Tech Tip
NO. 00006 PAGE 1 OF 1

N17xx NuVinci HUB

Shift Rod

June 13, 2007 REV. 01

0160 Shift Rod

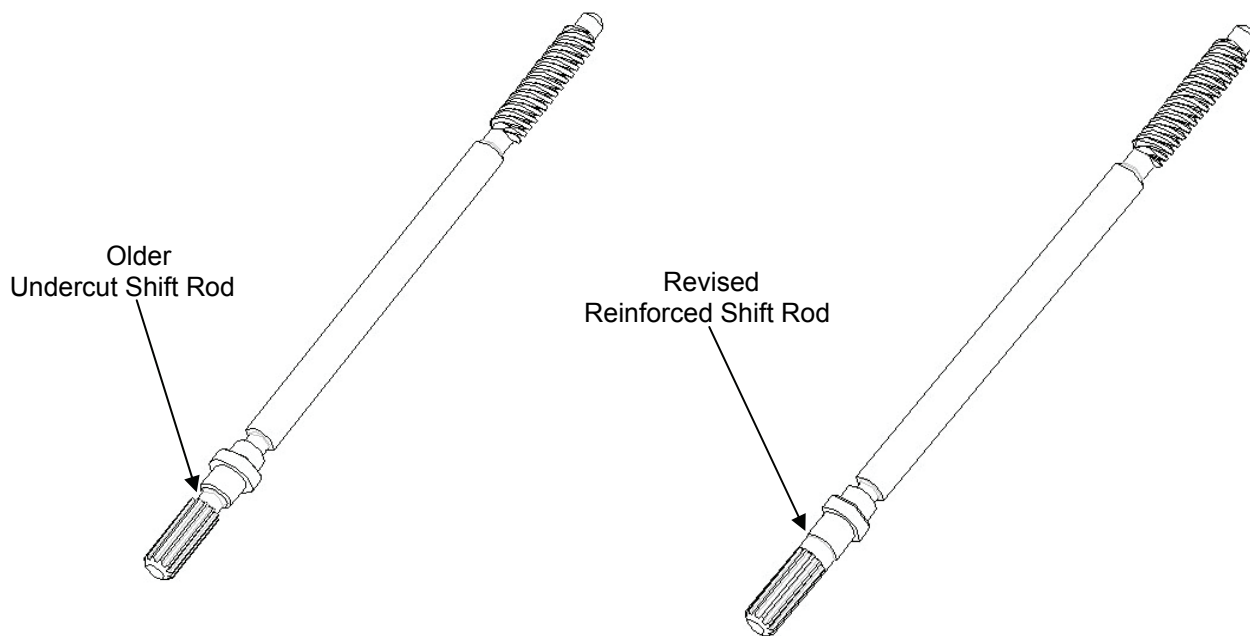
Change in Shift Rod Design

Revised shift rod has reinforced neck.
Both older and revised shift rod are interchangeable on all N17xx hubs.
